## **Notice of Modification**

## Section 75W of the Environmental Planning and Assessment Act 1979

The development consent (DA 29/95) for the Austar Coal Mine, granted by the Minister for Planning on 14 February 1996.

Figure 1: Stage 2 longwall panels

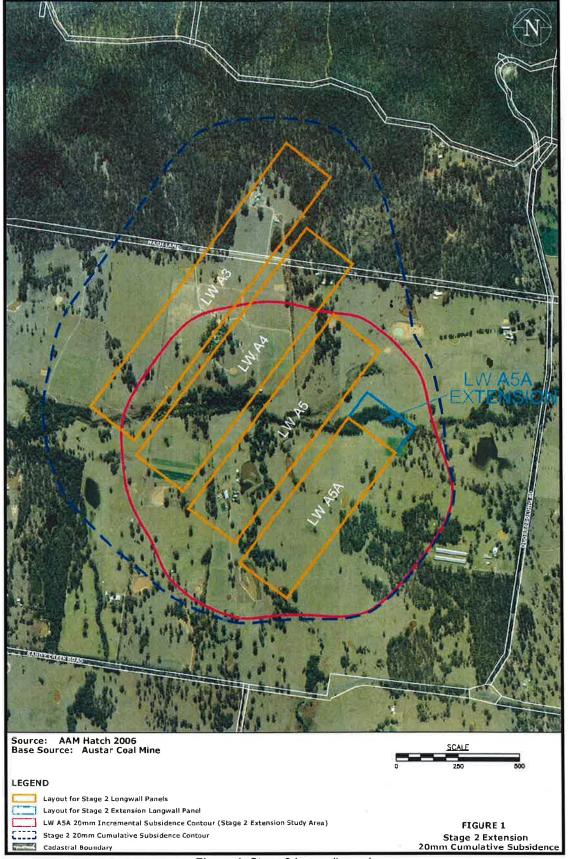
- 2. Insert "and Infrastructure" following each reference to "Department of Planning".
- 3. Delete the reference to "A6 A17", and insert "A7 A19".
- 4. Delete all references to "Director-General of I&I NSW", and insert "Executive Director, Mineral Resources".
- 5. Delete all references to "DECCW", and insert "EPA".
- 6. Delete all references to "I&I NSW", and insert "DRE".
- 7. In condition 2 of schedule 2, delete all words after "July 2010; and", and insert the following:
  - (f) modification application DA 29/95 MOD 5 and EA (MOD 5); and
  - (g) the conditions of this consent.
- 8. In Appendix 2, delete Figure 1 and insert the following:
